City of Sugar Hill
Planning Staff Report
DRB TCO 17-01893

DATE: August 1, 2017
TO: Mayor and Council, Design Review Board
FROM: Planning Director *VA*
SUBJECT: Town Center Overlay (TCO) Design Review
1329 & 1335 Hillcrest Drive, Southern Heritage Home Builders

SIDE & REAR ELEVATIONS

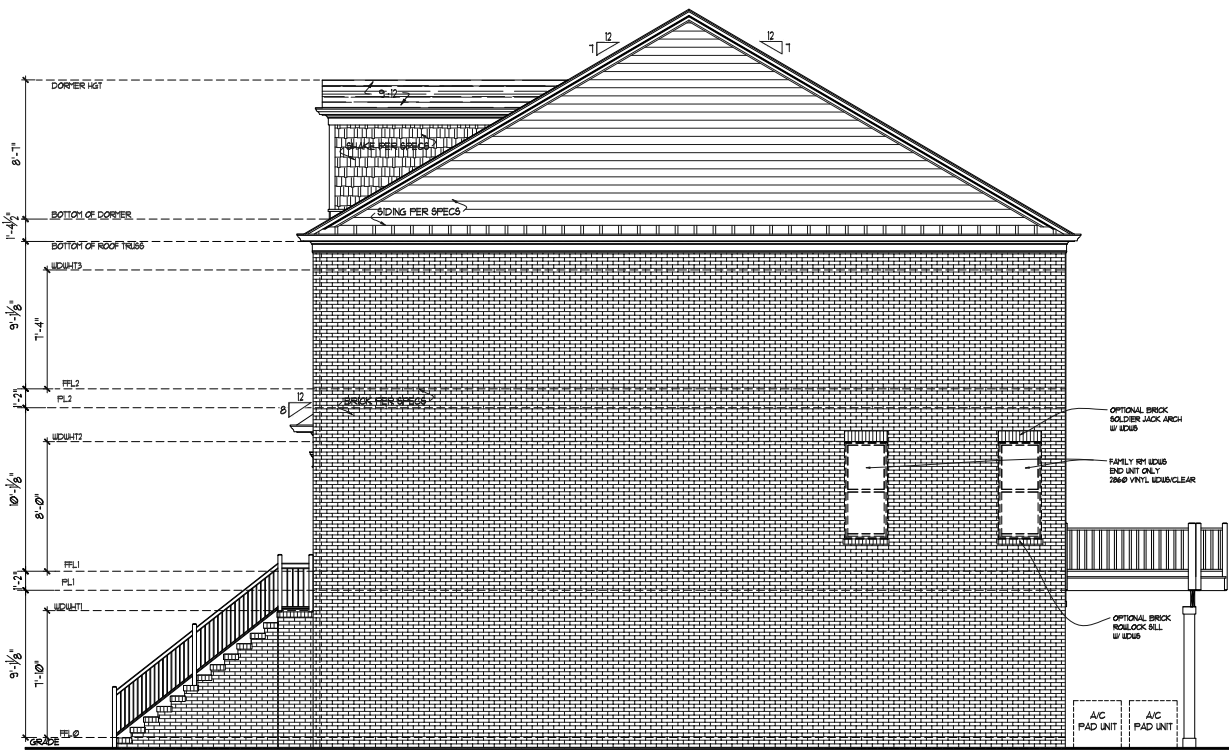
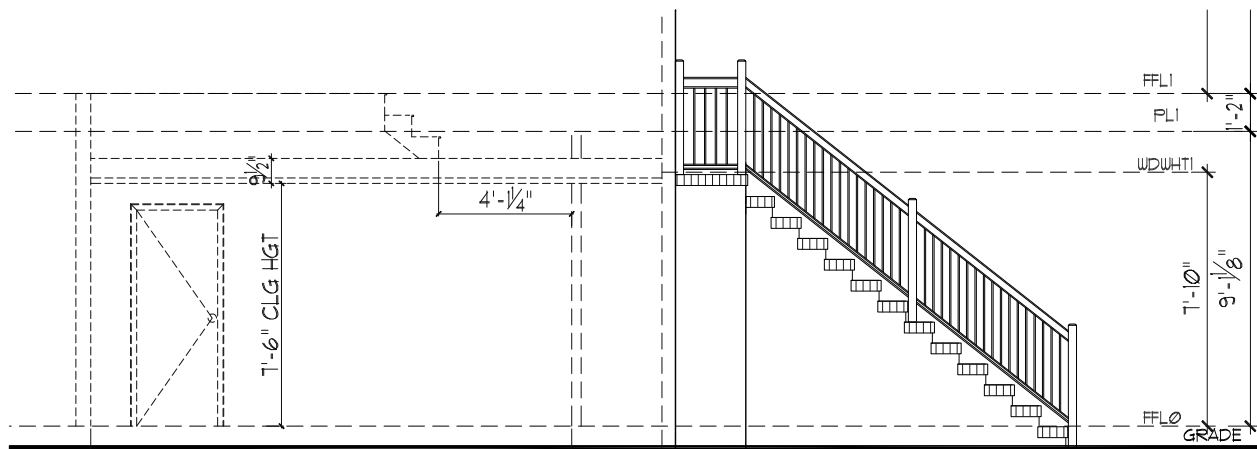
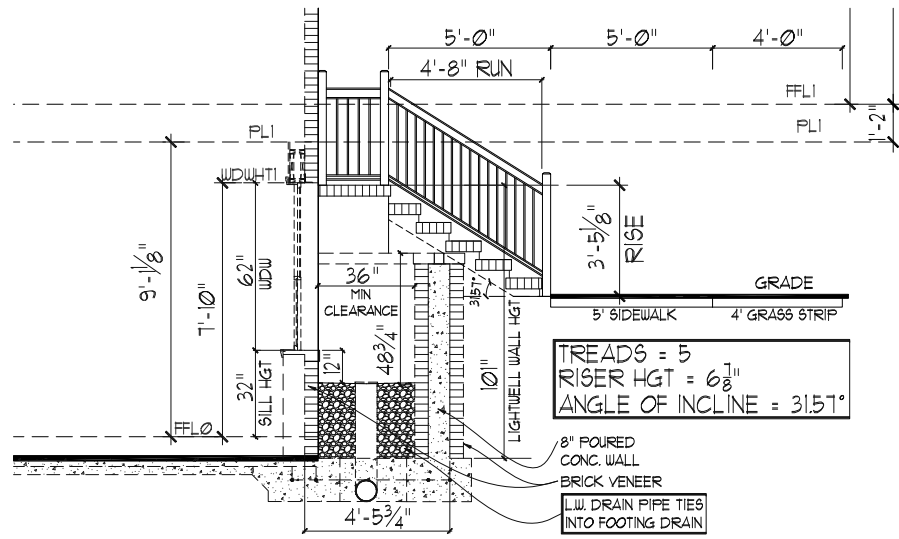
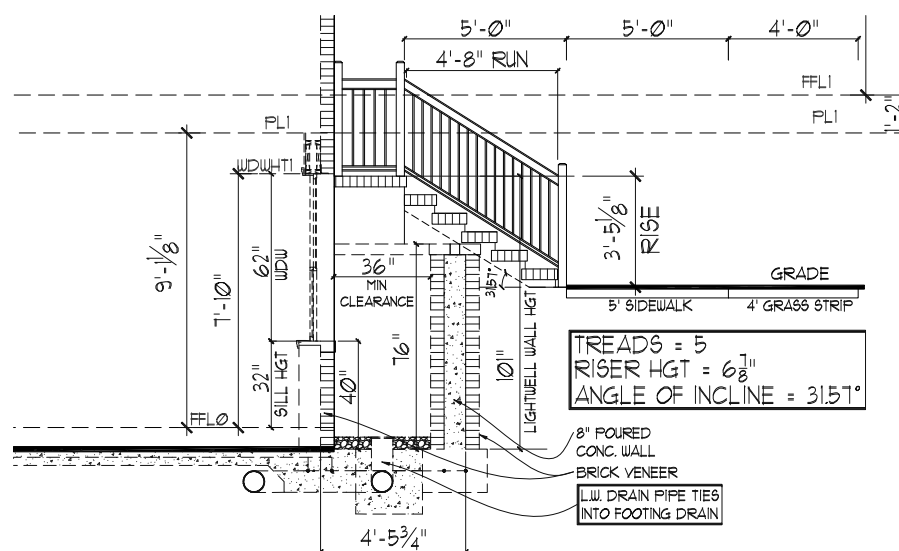
- The side façades of the end units appear to lack sufficient expressive character. Additional windows and/or appropriate structural articulation should resolve the issue.
- Current architectural standards limit siding to 20% of side / rear facades.
- Town Center Overlay District requires design review approval by City Council.

Except for a few design details on the side facades and rear façade material selection, yes. From Section 1001, TCO Overlay, E. Design Criteria and Standards, 1. Design Criteria – Architectural Design: “Each individual building or project must contribute to a consistent architectural identity for the TCO by using traditional forms, authentic materials, and quality craftsmanship.”

5. Windows and façade articulations shall be placed in a regular pattern and relate to doors, columns, and other façade articulations.
6. If used, shutters shall be sized exactly half the size of the window. Curved shutters must match the curve of the window. Shutters must be mounted directly to the casing with proper shutter hardware.

7. The following architectural design conditions are prohibited: Material changes on outside corners. Recessed front porches. More than two principal building materials. Chimneys on outside walls that do not extend completely to the ground.
